Origination Form
Proposed Revisions to a Standard Plans Index

Originator:	Caldwell, Carey Allie	Index Number:	711-002
Date:	5/6/2026	Sheet Number(s):	1, 2
E-mail:	carey.caldwell@dot.state.fl.us	Index Title:	Bicycle Markings

LAST REVISION 11/01/17 11/01/26	REVISION DESCRIPTION:	 FY 2026-27 STANDARD PLANS	BICYCLE MARKINGS	INDEX 711-002	SHEET 1 of 2
--	--------------------------	---	------------------	------------------	-----------------

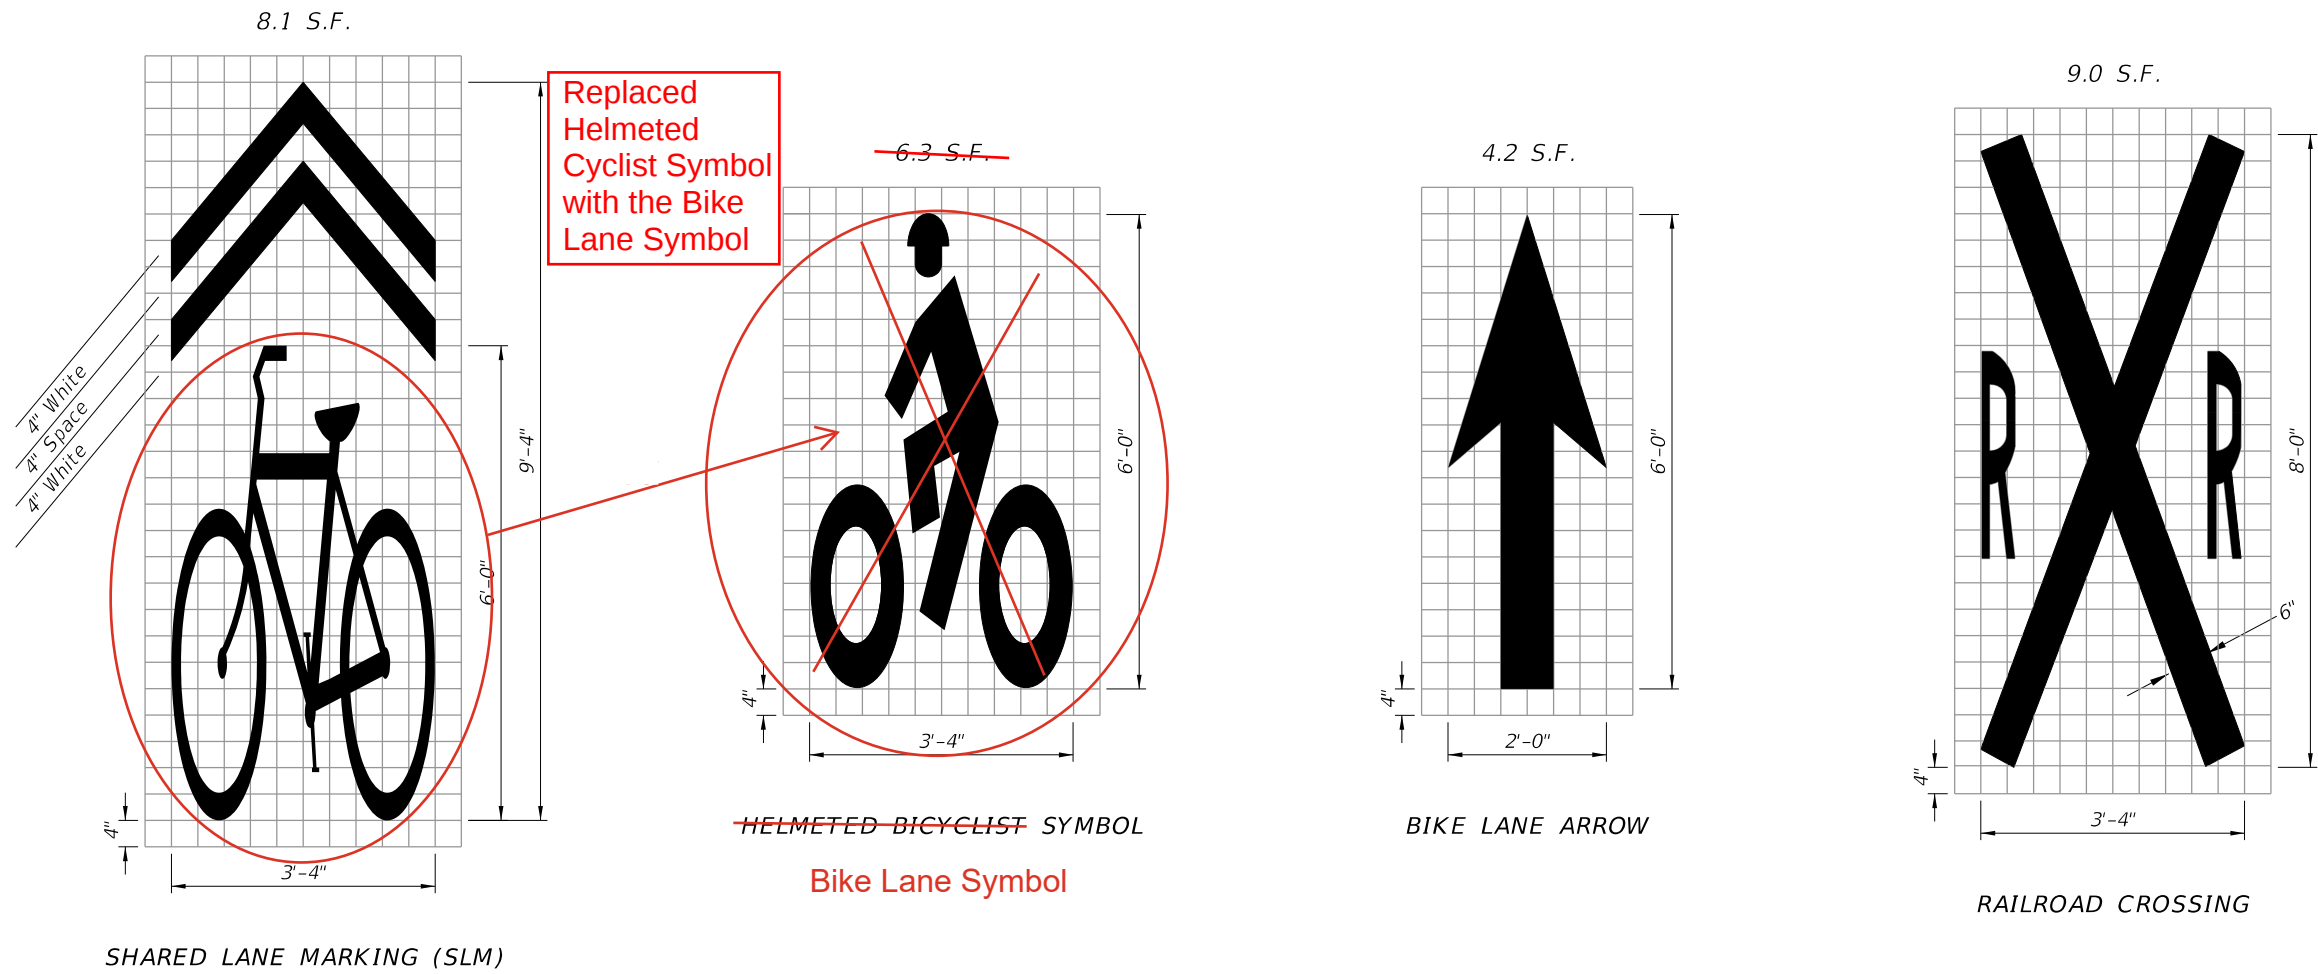
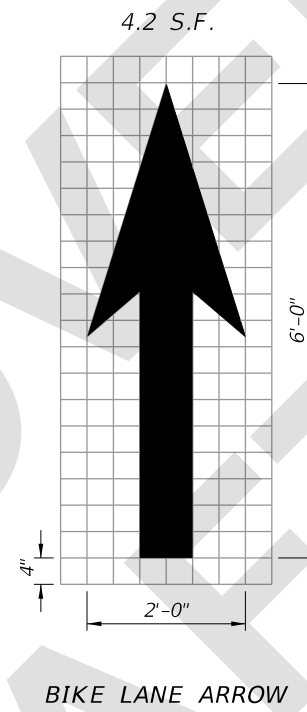
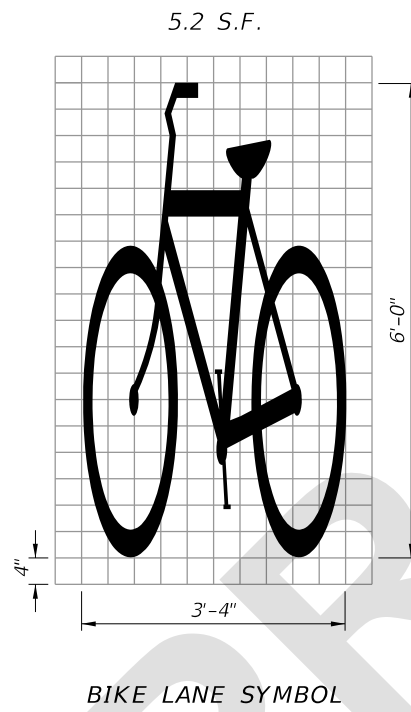
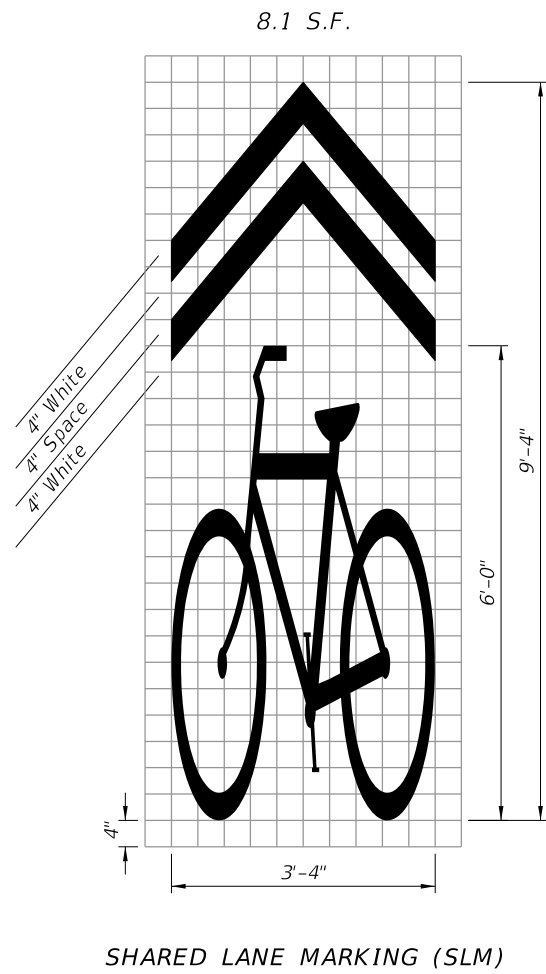
All: Updated bike lane symbols

MUTCD 11th Edition has removed the helmeted bicyclist symbol and therefore all FDOT Standards and Criteria must be updated accordingly.
